CODAN

Y2k compliance upgrade for the Fax and Data Interface 9001

Figure 2: PC Expansion PCB

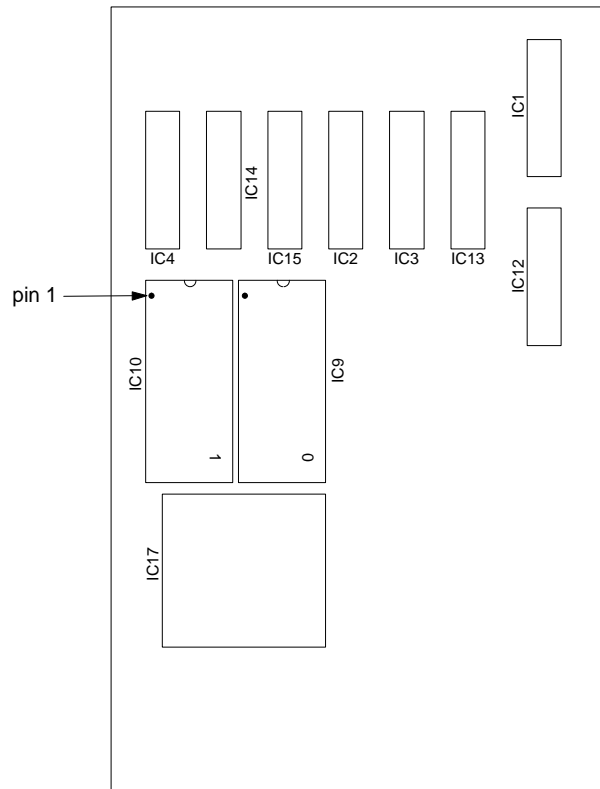
- Locate IC9 and IC10 on the PC Expansion PCB (see Figure 2).

- Check the software version on the label of IC9 and IC10.

If the software version is less than 2.52, the software must be upgraded. Contact Codan for the new software (part number 90-20527-001).

- Note the orientation of IC9 and IC10 and remove them from the PC Expansion PCB.
- Correctly orientate and fit the EPROM, labelled **0**, in the position that IC9 occupied.
- Correctly orientate and fit the EPROM, labelled **1**, in the position that IC10 occupied.
